*CONTAMINATED SOILS ADJACENT TO THE SEWAGE
TREATMENT PLANT INCINERATOR*

DOE-1980-93

RESPONSES

**Responses to General USEPA Comments on the
Removal Action 14 Work Plan Addendum**

FIGURE 1, RADIOLOGICAL WALKOVER SURVEY MAP

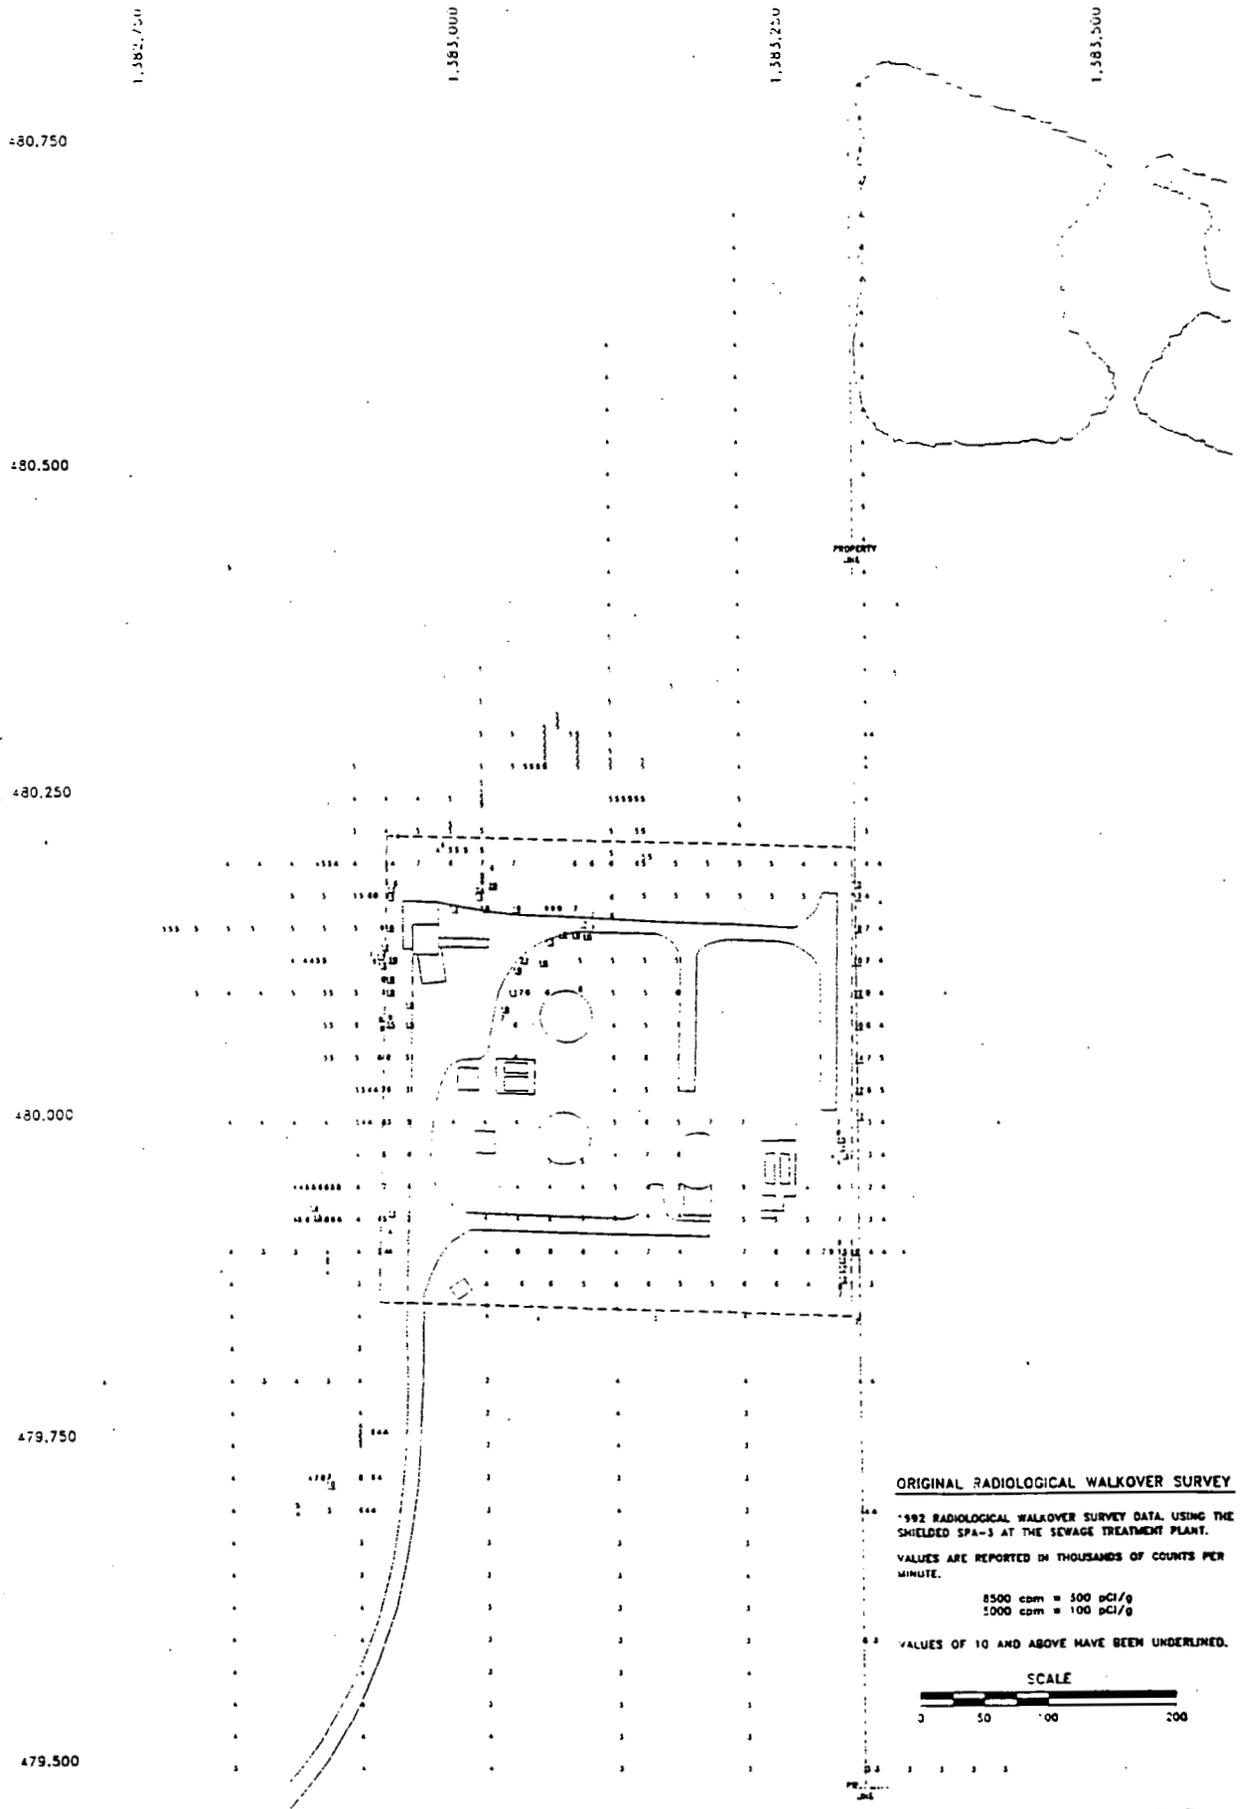
Appendix I, Figure 1: Location Number 11 detected Uranium near 100 pCi/g and 30 pCi/g of thorium. Additionally Cesium-137 and radium were detected. No additional sampling occurred around this point in any of the subsequent sampling points. DOE must include an evaluation of contamination in the area of the sampling location within the revised Phase III.

Appendix II, Radiological Walkover Survey: The walkover survey data supports the previous comment about additional sampling and potential excavation around Location Number 11.

Appendix IV, Table 2, and Figure 2: Because ASI-2 is 152.0 pCi/g, DOE needs to collect additional samples between this point and C-4 to determine the extent of contamination and evaluate the need for excavation of on-property soils.

Response #4

The 36.9 pCi/g of Th-234 listed in the results of analyzing the Location #11 sample is due to U-238 with which it is in secular equilibrium. The nearly 100 pCi/g of total uranium seen in the sample is made up of approximately 46 to 48 pCi/g each of U-238 and U-234, and a small amount of U-235, seen as approximately 2.27 pCi/g. Since Th-234, half-life of 24 days, is the immediate, short-lived daughter of U-238, one would certainly expect to see a concentration similar, given experimental error, to U-238 which is approximately 46 pCi/g.

The original map shows Location #11 as being off-property. After checking with the sampling contractor, these coordinates were found to be in error. The revised coordinates should be North 480452 and East 1383296. These revised coordinates place the sampling point on-property. The revised coordinates for Location #11 have been verified in the field. Also, four additional SPA-3 survey measurements were performed within a foot of Location #11 and the results are provided in the table below.

The original walkover survey map did not delineate all of the survey points taken north of the incinerator. On the map it appears that there is a data gap between the leading edge of the 100 pCi/g plume and the off-property area northeast of the incinerator when in actuality there are survey points in this area. This data was already in the Walkover Survey Results table included in the Work Plan Addendum, but the survey points were not included on the map because no locations were found to exceed the 100 pCi/g action level.

As a result, the survey map, Figure 1, has been updated to include ALL survey points taken during the original walkover survey.

FIGURE 2, SOIL SAMPLE LOCATION MAP

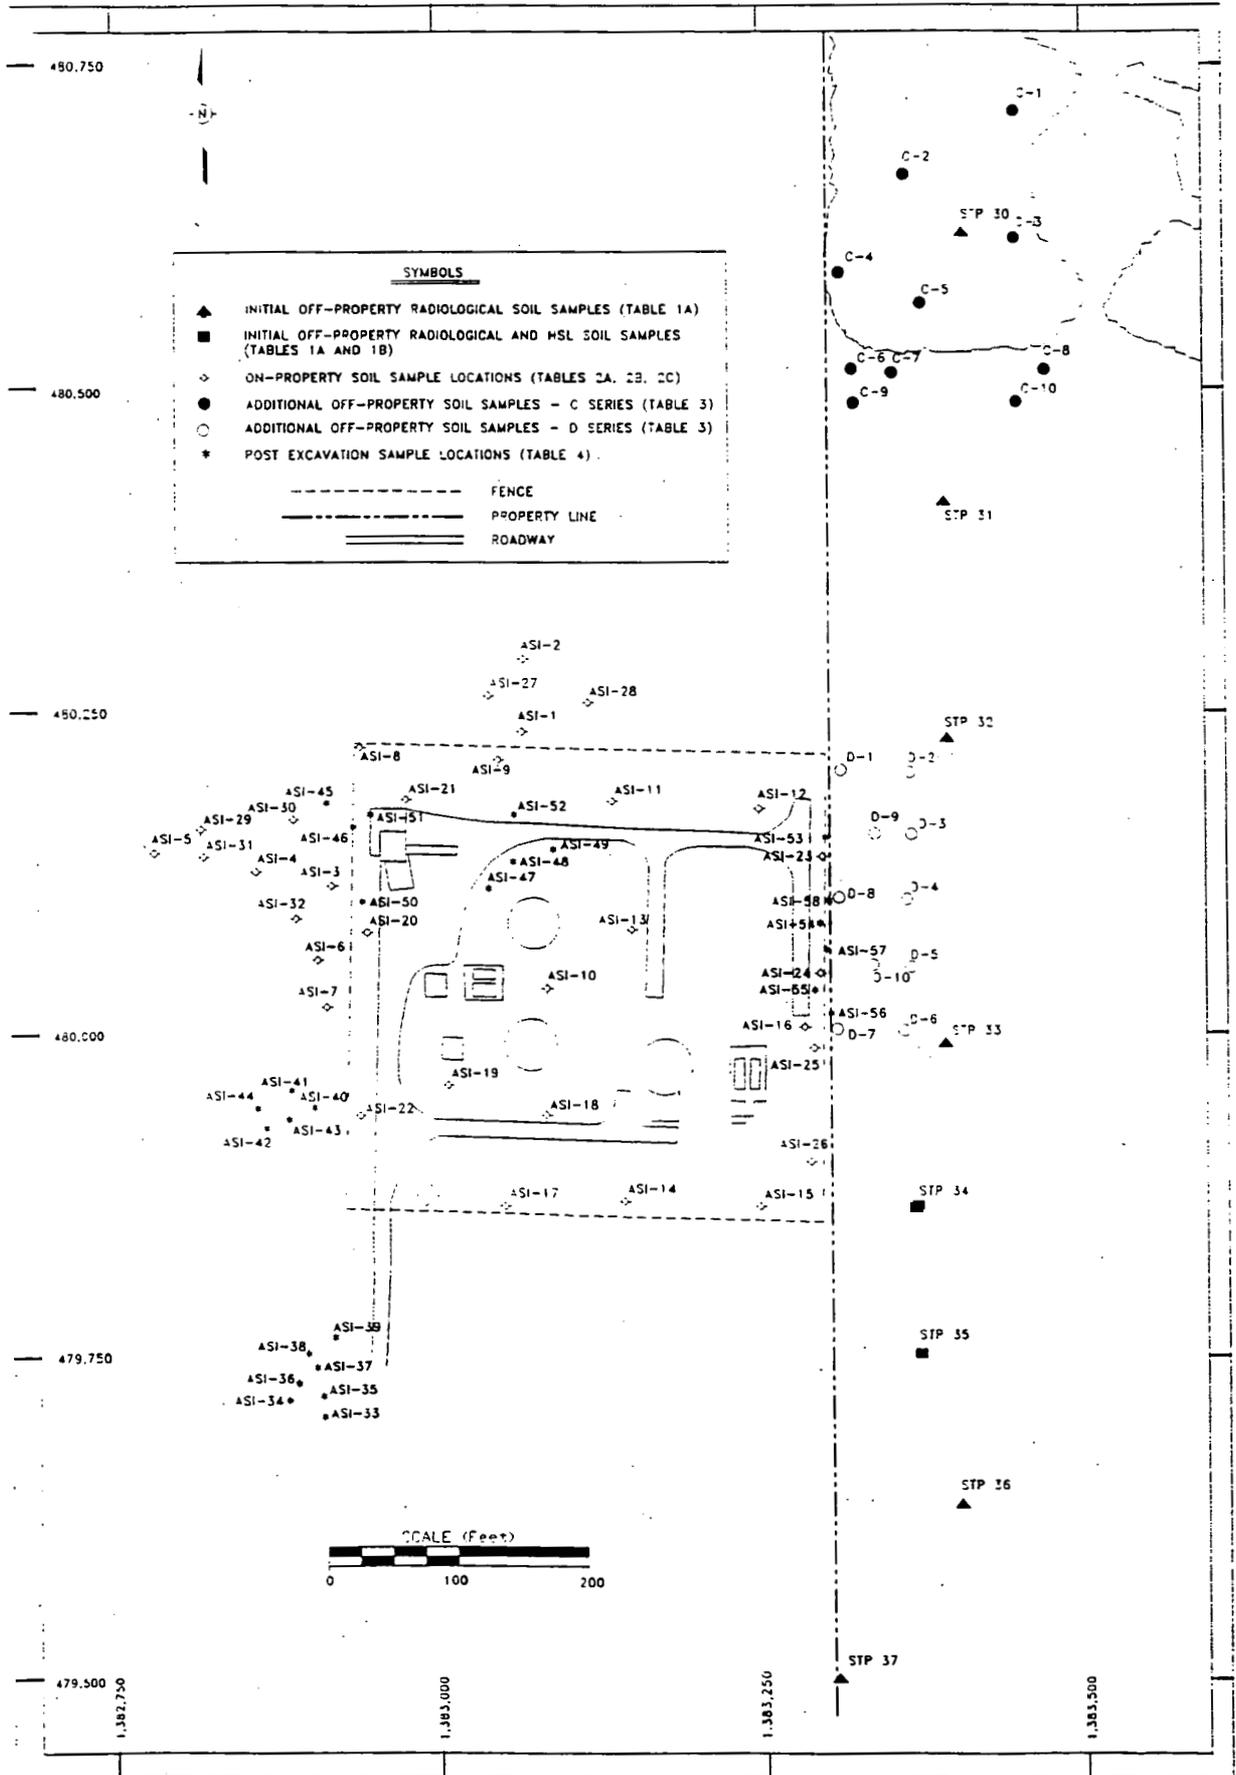
Appendix IV, Figure 2: Based upon review of the sampling locations and data, it is evident that DOE has failed to even delineate the extent of soils exceeding 35 pCi/g of Uranium off-property. Phase III of the Removal Action should be aimed at addressing off-property soils with Uranium concentrations in excess of 35 pCi/g as well as assessing other radionuclides present.

Appendix IV, Table 3 and Figure 2: Since C-1 is 47.3 pCi/g, DOE needs to collect additional samples north and east of this point to determine the extent of contamination. This information will be necessary for the OU5 RI Report.

Response #6

As discussed in the response to OEPA General Comment #1, efforts are currently underway to delineate the extent of soil contamination surrounding the two off-property areas already determined as having total uranium contamination greater than 35 pCi/g. Additional surveys and intrusive samples will be taken to delineate the off-property contamination. The strategy for collecting these additional data are enclosed. The C and D location samples previously collected were also analyzed for isotopic uranium, isotopic thorium, radium 226, and radium 228. Results of these samples are in Table 3.

Response #7

See responses to OEPA General Comment #1 and Specific Comment #6. Additional walkover surveys will be conducted, as described in Appendix V, to determine the extent of off-property contamination. This walkover will include the areas north and east of location C-1. Intrusive samples will be taken at the boundaries to verify the walkover surveys.
